Service Bulletin

AUTOMOBILE	
ISSUE NO. :	Q-SN-004
DATE	: Apr. 09, 2009
PAGE	: 1 OF 5

SUBJECT	: Steering vibration
APPLICABLE MODEL	: SN413(JS3JB43V834161319~ JSAFJB43V00170547~) SN415(SOP~)
EFFECTIVE ENGINE OR FRAME NO.	: 2009/3/2~ JSAFJB43V00422454~ (E02,E06,E11,E21,E22,E24,E37) JSAFJB53V00420452~ (E22) JS3JB43V3A4100053~ (E10) JS3JB43V694103542~ (E43) JS3JB43V294103554~ (E50) JS3JB43V694103556~ (E85)
REFERENCE	:

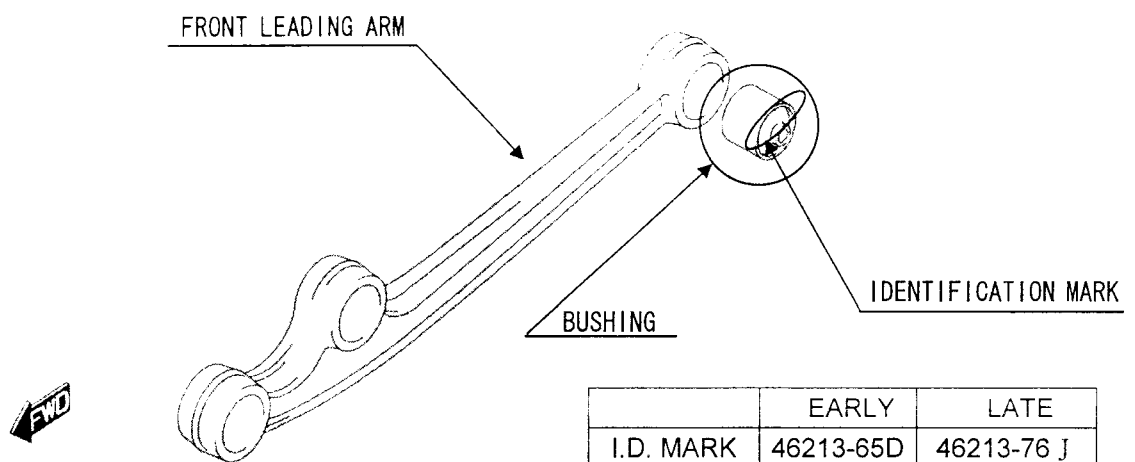
- By improving spring characteristic of front leading arm bushing, vibration transmission characteristic on front suspension has been changed.
- Shim has been set up as an optional part in order to adjust friction of steering system.

(1) Work Flow Chart

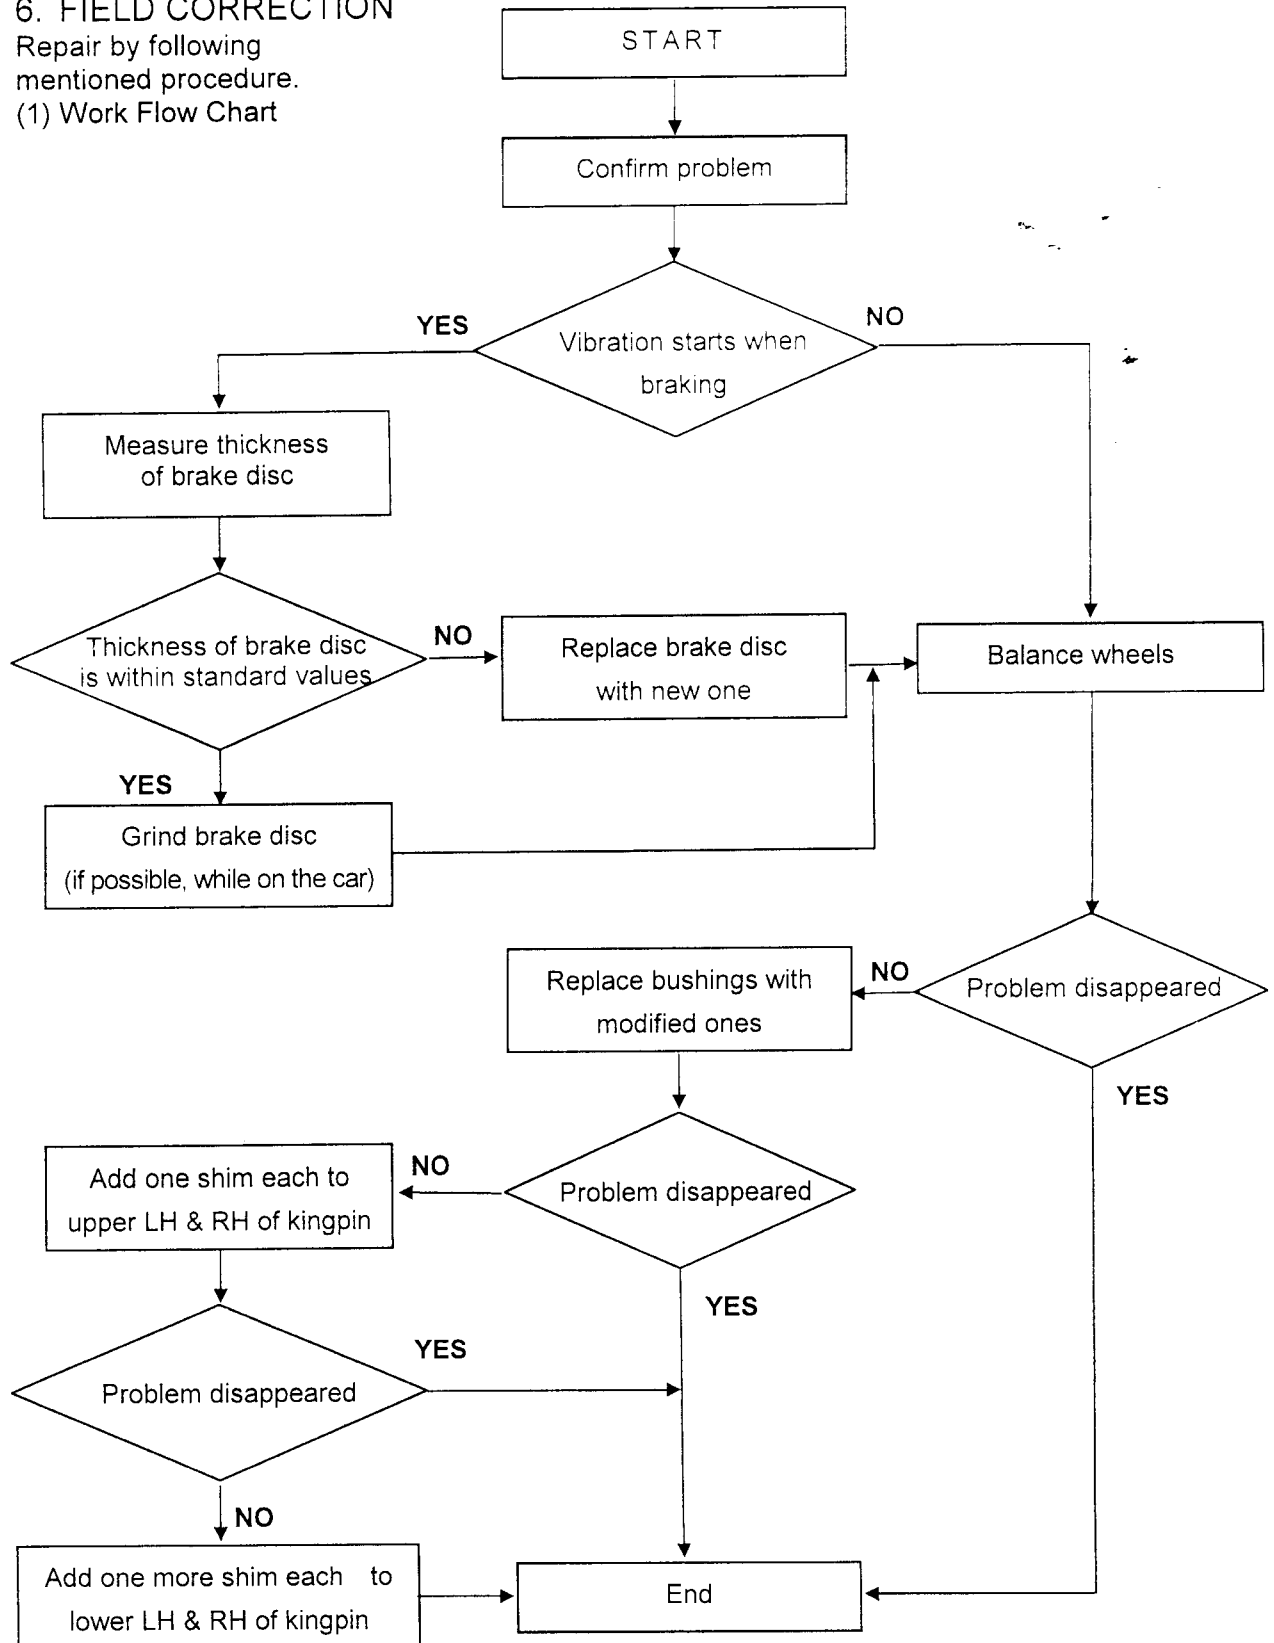
Repair by following mentioned procedure.

FIG-1 : Location of additional shim

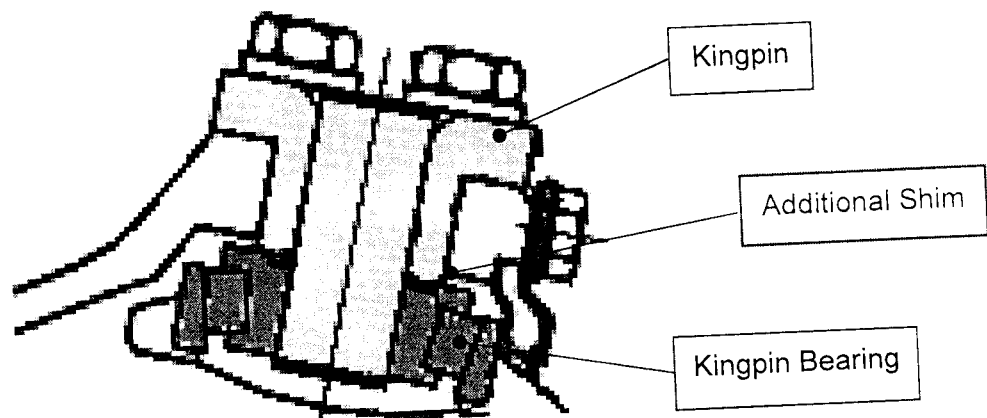
1. Remove kingpin, install the shim (FIG-1), and reinstall kingpin.
(Follow service manual for removal and assembly of the kingpin)

Put one shim in between kingpin and kingpin bearing.

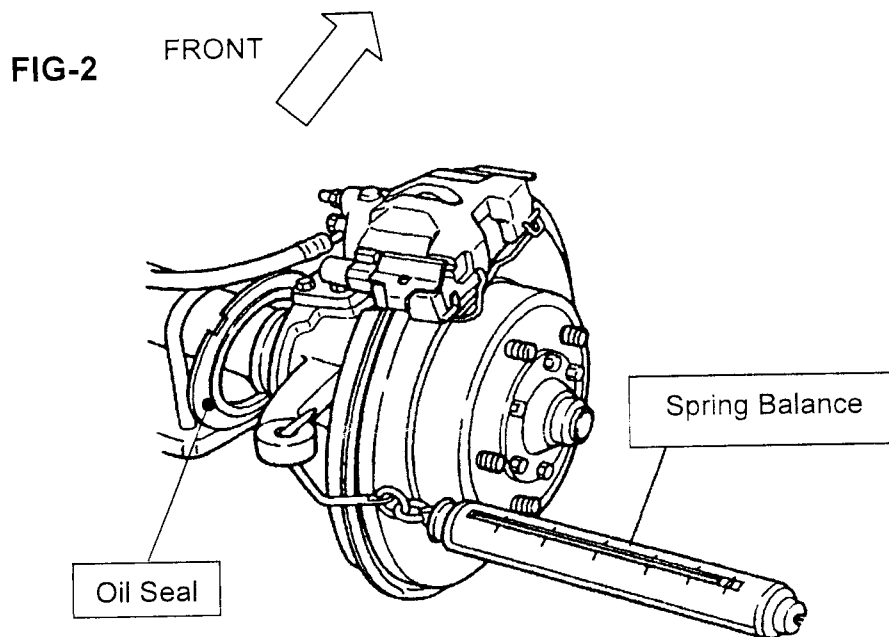
2. After adding shim, remove oil seal, tie-rod, and drag rod which are assembled on steering knuckle. And then, after shaking knuckle right and left around 20 to 30 times, measure start-up load by hooking a spring balance to tie-rod fixing hole of knuckle arm (which extends toward the rear of vehicle). Make sure start-up load is 4.6kg(45N) or less (Ref. : FIG-2).

Please make sure start-up load should stay 4.6kg(45N) or less. If start-up load exceeds 4.6kg(45N), it might cause loss of steering returning performance or/and damage of kingpin bearing.
